Cordillera Valley Club

Rubin Residence - Modification to Approved Plans

322 Legacy Trail / F9 L11

Cordillera Valley Club Design Review Board *Staff Memorandum*

1 CONSTRUCTION MGMT
1" = 10'-0"

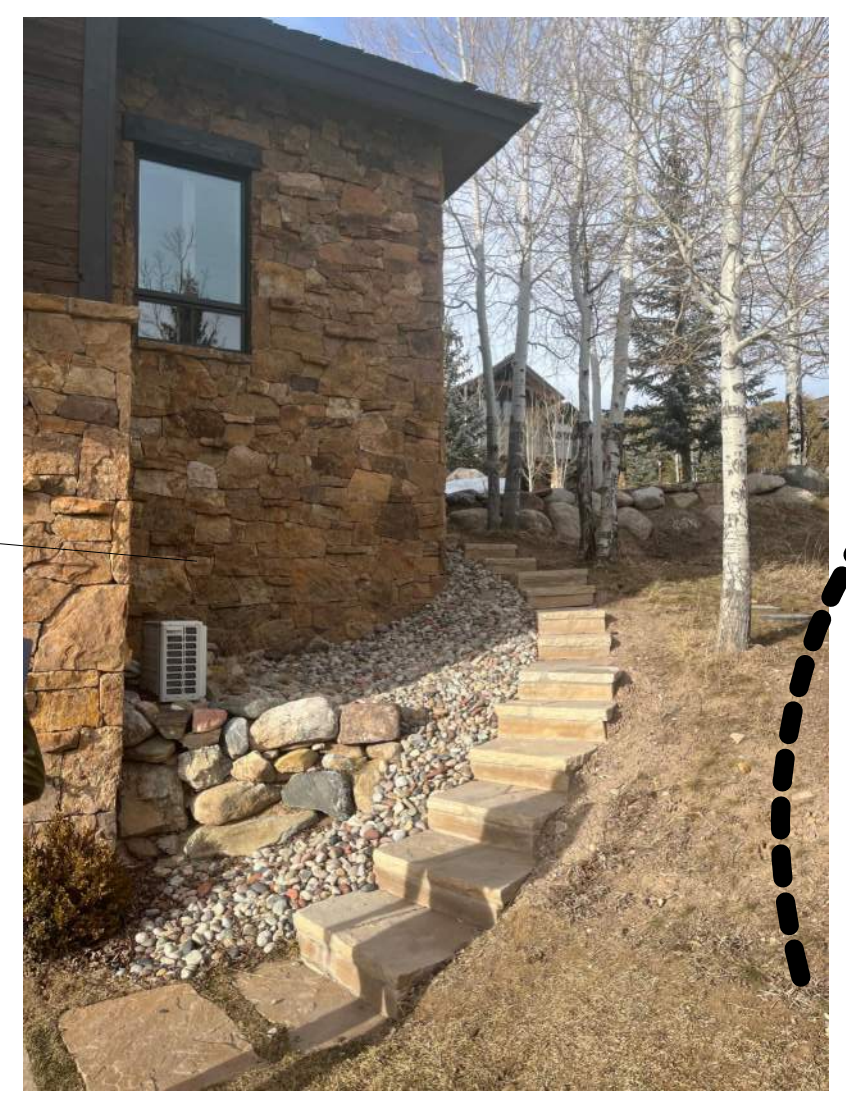
The construction management plan is also described in broad strokes. The access to the back and west of the house to complete the remodel has 3 options. Option 3 which would be to use the unapproved cart path and enter via the west side of the Rubin Residence would likely require removal of all the existing trees and scrubs without any mention of commitment of replacement. Moreover, as full time residences in our home it would be an intrusive path for us.

Additionally, the parking that has been mapped out on paper looks doable; however, as you and I know it is not how it happens in reality. Is there a plan on ensuring the execution of the construction management including the parking? Will parking be supervised by an onsite construction manager?

1 SOUTH ELEVATION
1/4" = 1'-0"

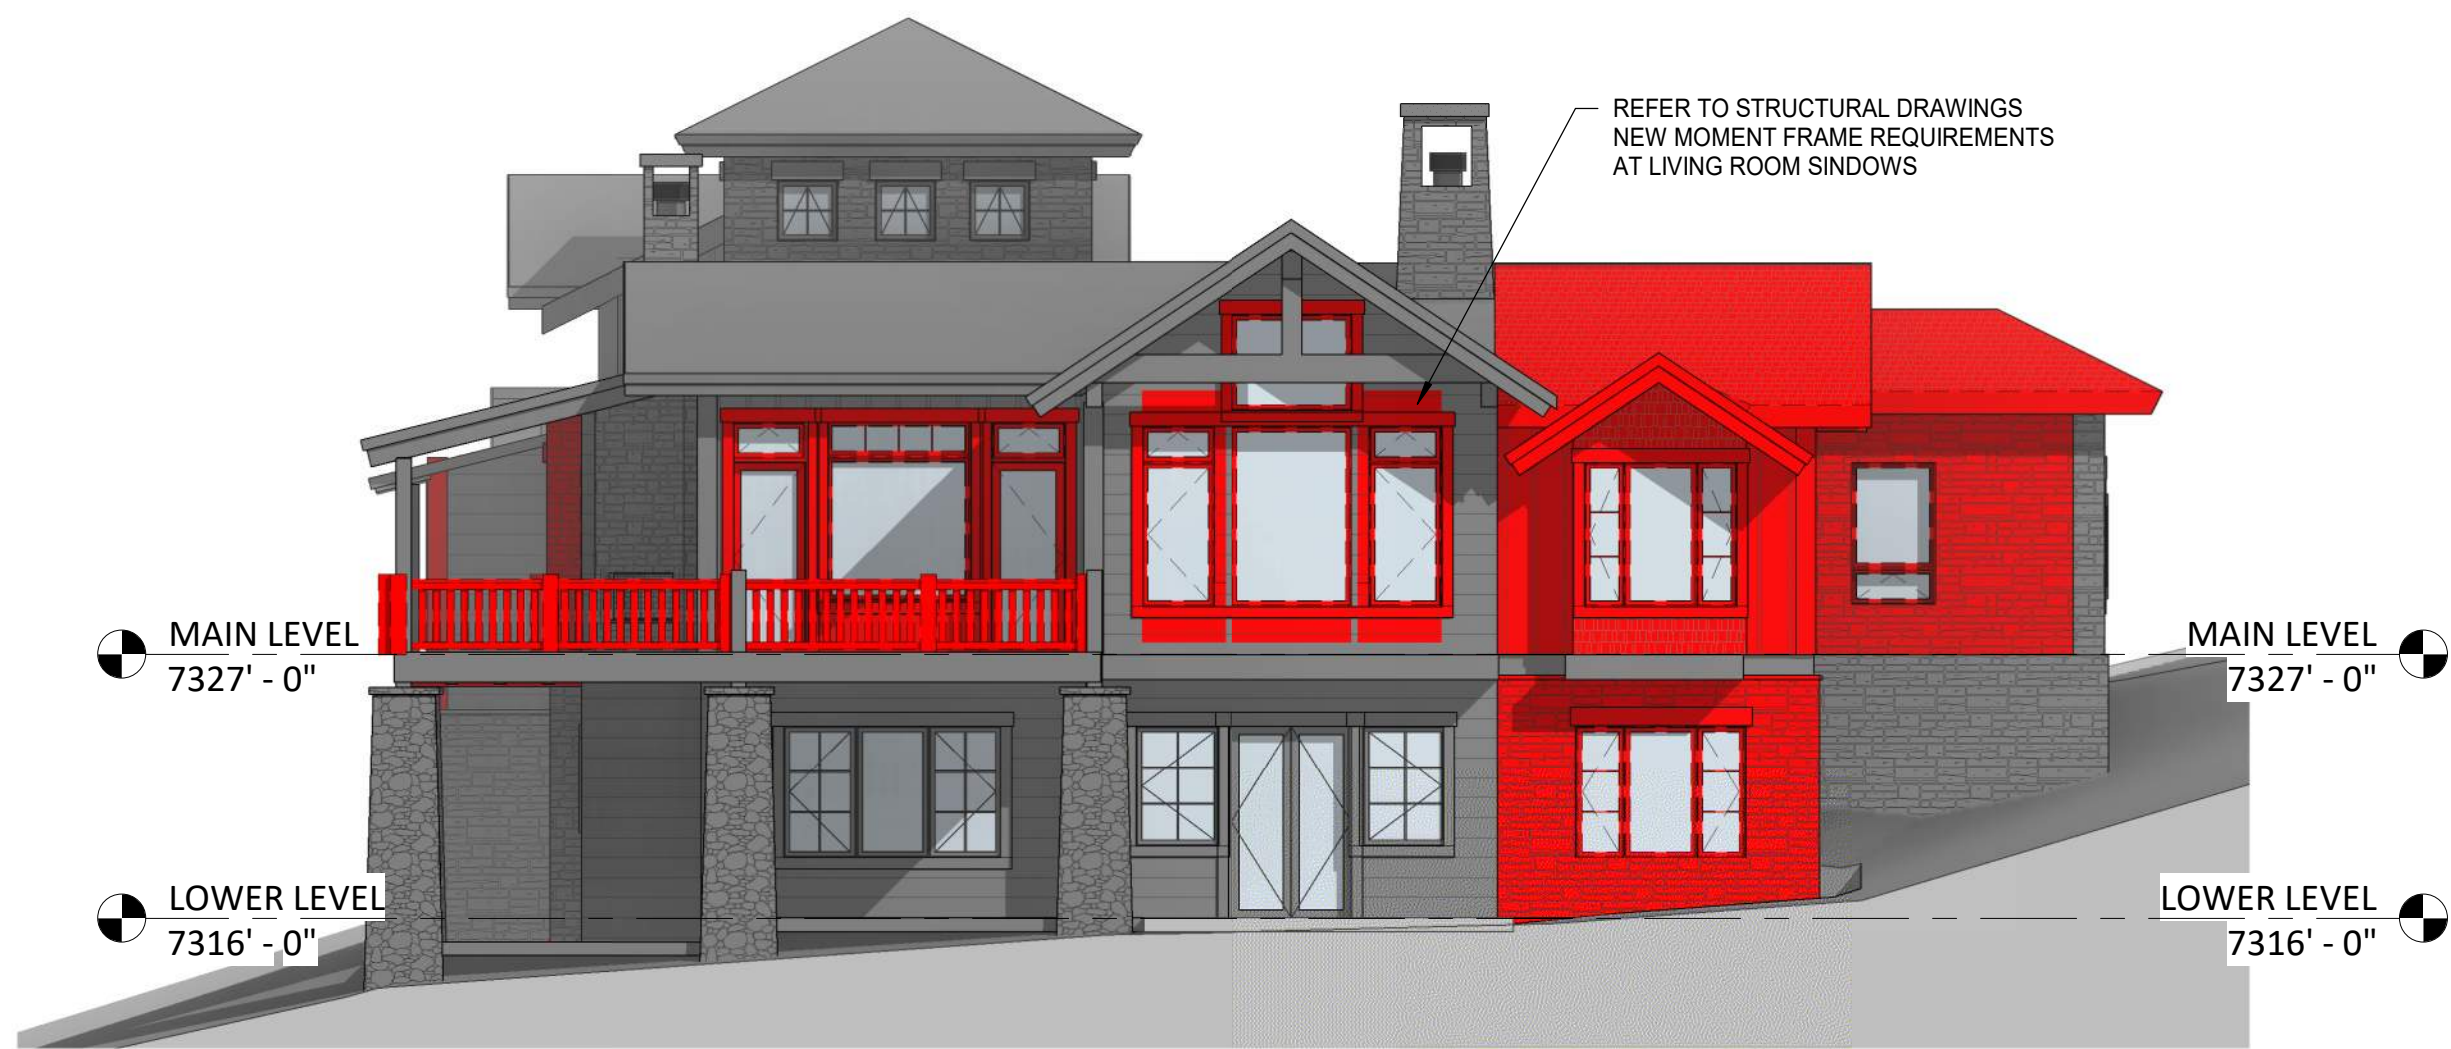
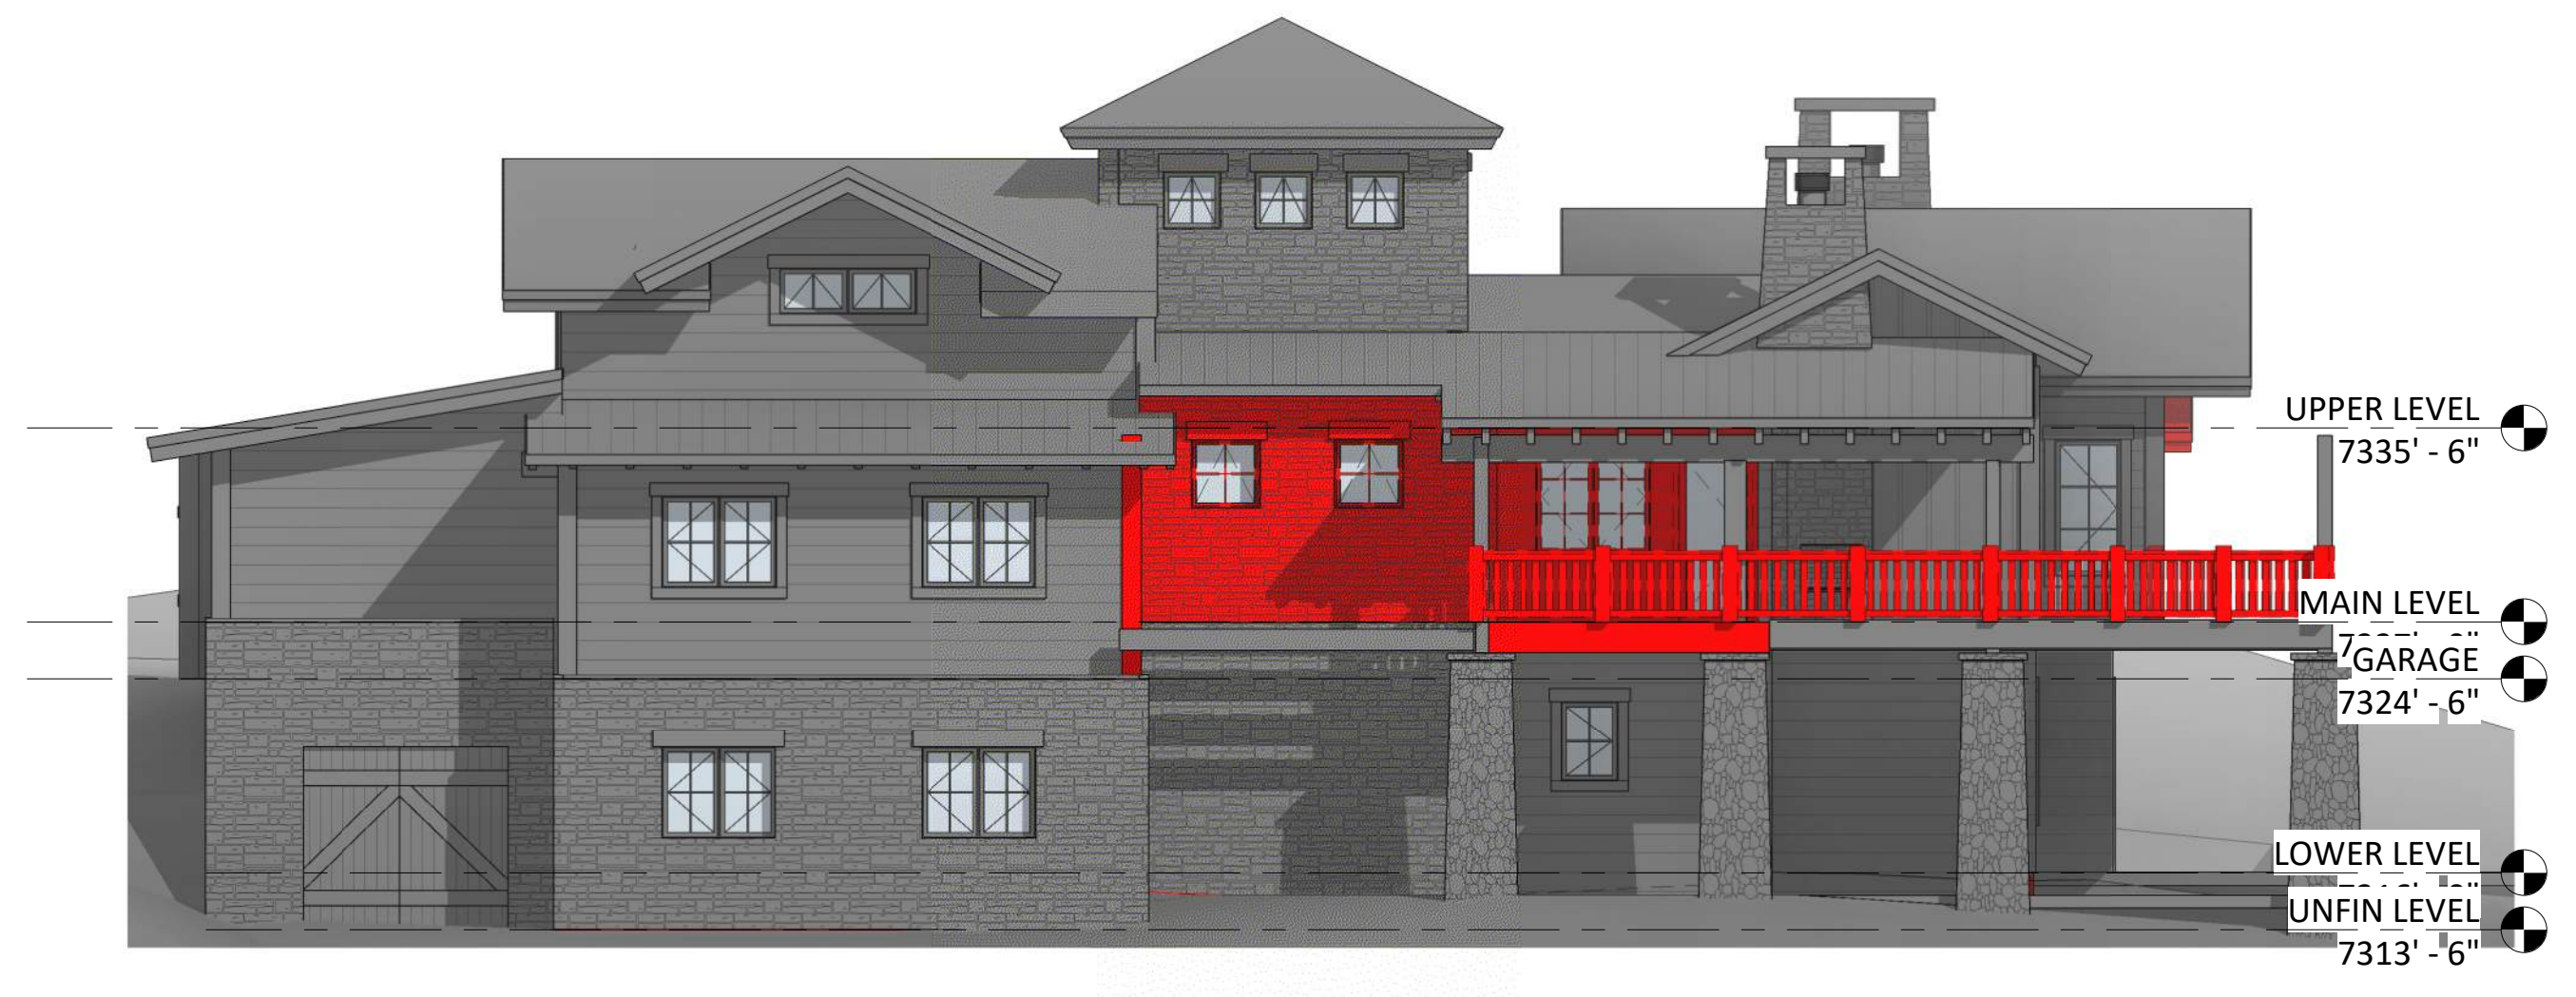
1. At the previous meeting, the DRB stated that the number of columns for the deck needed to be reduced. Staff believes that the change of the deck design, which eliminated 2 of the 4 columns, is a positive change to the design. The DRB should provide input on the deck design.
2. The addition of the roof over the deck is within the building envelope and does not require a deviation from the Design Guidelines. However, staff believes that the DRB should provide input on the new roof area. The Design Guidelines state:

Allison,
Attached are the drawings with the revised south elevation that shows the entire South elevation (Proposed)

- The smaller deck expansion (327 s.f.) is revised to have (2) stone columns support columns instead of the (4) previously shown and approved by the DRB. We thought that this was important to respond to this comment from the board. The resulting long beam will be steel with a timber wrap to mimic other structural elements of the home. This also will position the activity on the deck area further away from the west neighbor's direct sight line.

- We reviewed the west deck and listened to the comments of the west neighbor. It was found that the sun at the west deck area is very intense and we are now proposing a new timber roof structure over the new portion of deck. We looked at several options for the roof design but selected a 3:12/low pitch roof (matching the existing kitchen pitch) with a gable shape to be the least intrusive and would preserve the views best as one looks north to south along the home. A single pitch/shed resulted in a higher roof ridge and extending the dining roof was deemed too large. The roof's gable timber truss will mimic the Living room south truss, just at a lower pitch roof.
